CEVNI
European Code for Inland Waterways

Resolution No. 24

Revision 5

Amendment 4

IX. Annex 3

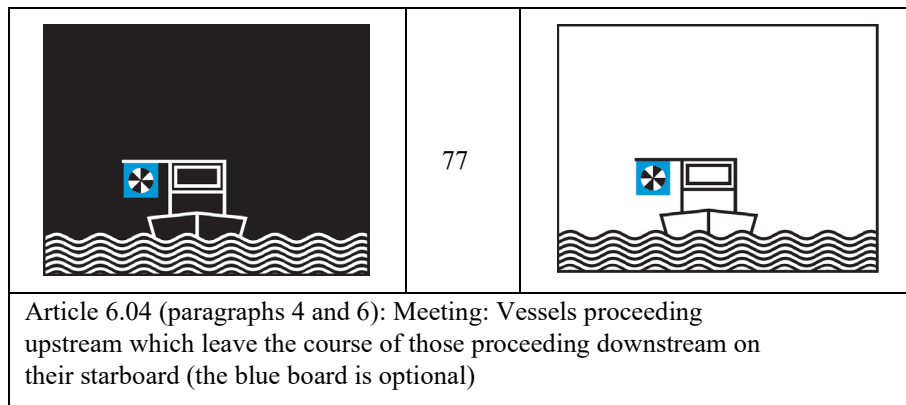
- 13. Sketch 20, in the end *add* "(masthead lights are optional)".
- 14. *Add a new sketch 20bis*
